**County of San Diego
Planning & Development Services
BUILDING DIVISION**

ACCESSIBILITY CORRECTION LIST Multifamily Housing	2A
Parking Facilities

**FIGURE 11A-2B
SINGLE AND VAN ACCESSIBLE PARKING STALLS**

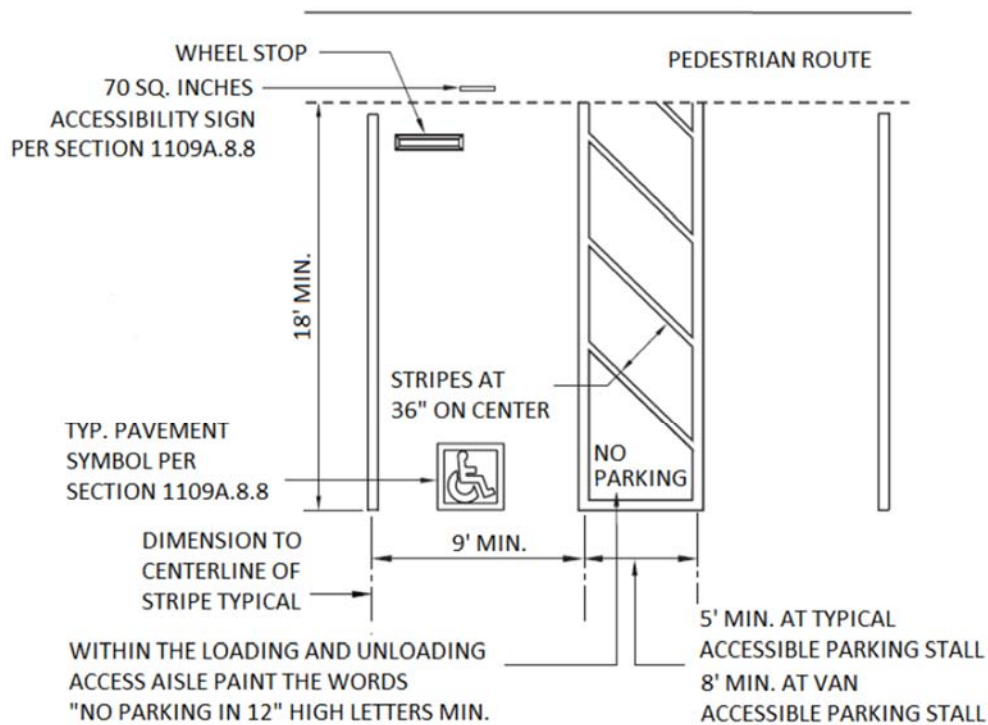
- 13. Provide complete dimensions and coordinated detailing for each accessible parking space. *CBC 1109A.8*
- 14. Where individual accessible parking spaces are provided, dimension the following per CBC Figure 11A-2B:
 - Standard accessible parking spaces:
 - Minimum 9-foot-wide by 18-foot-long parking stall with minimum 5-foot-wide by 18-foot-long parking stall located adjacent to either side of parking stall
 - Van accessible parking spaces per **one of the following:**
 - Minimum 12-foot-wide by 18-foot-long parking stall with minimum 5-foot-wide by 18-foot-long access aisle located on passenger side of parking stall with the vehicle parked in the forward position
 - Minimum 9-foot-wide by 18-foot-long parking stall with minimum 8-foot-wide by 18-foot-long access aisle located on passenger side of parking stall with the vehicle parked in the forward position

**FIGURE 11A-2A
DOUBLE PARKING STALLS**

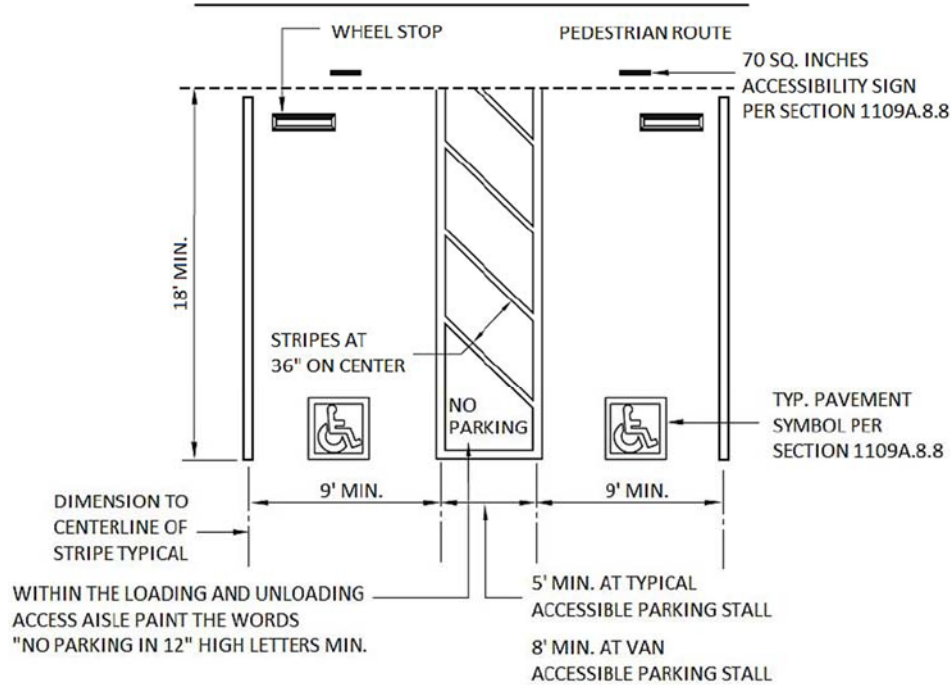
15. Where dual accessible parking spaces are provided, dimension the following per CBC Figure 11A-2A or CBC Figure 11A-2C:

- Two minimum 9-foot-wide by 18-foot-long parking stalls
 - Minimum 5-foot-wide by 18-foot-long access aisle between parking stalls
- Exception:** Minimum 8-foot-wide by 18-foot-long access aisle required on passenger side of van accessible spaces

FIGURE 11B-705.1
 SIZE AND SPACING OF TRUNCATED DOMES

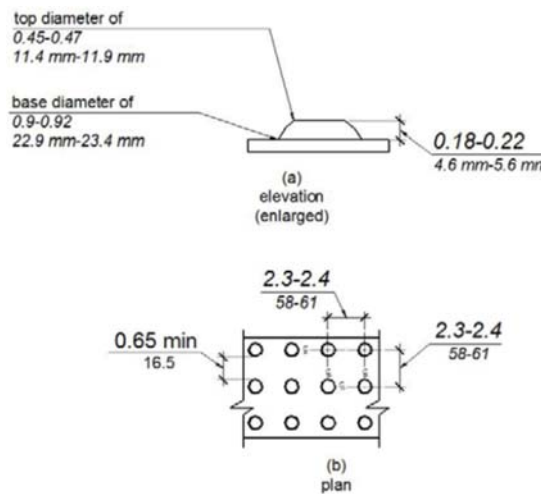
20. At pedestrian ways entering or adjoining parking stalls or access aisles without curb, railing, or barrier separation, detail continuous detectable warning strip complying with the following:

- 36-inches (absolute) deep for entire length/width of transition
 - Including raised, truncated domes per CBC Figure 11B-705.1:
 - o Minimum 0.9-inch and maximum 0.92-inch base diameter

- o Minimum 0.45-inch and maximum 0.47-inch top diameter
 - o Minimum 0.18-inch and maximum 0.22-inch height
 - o Minimum 2.3-inch and maximum 2.4-inch center-to-center spacing and minimum 0.65-inch base-to-base spacing**Exception:** Minimum 1.6-inch and maximum 2.4-inch center-to-center spacing acceptable for domes in radial pattern
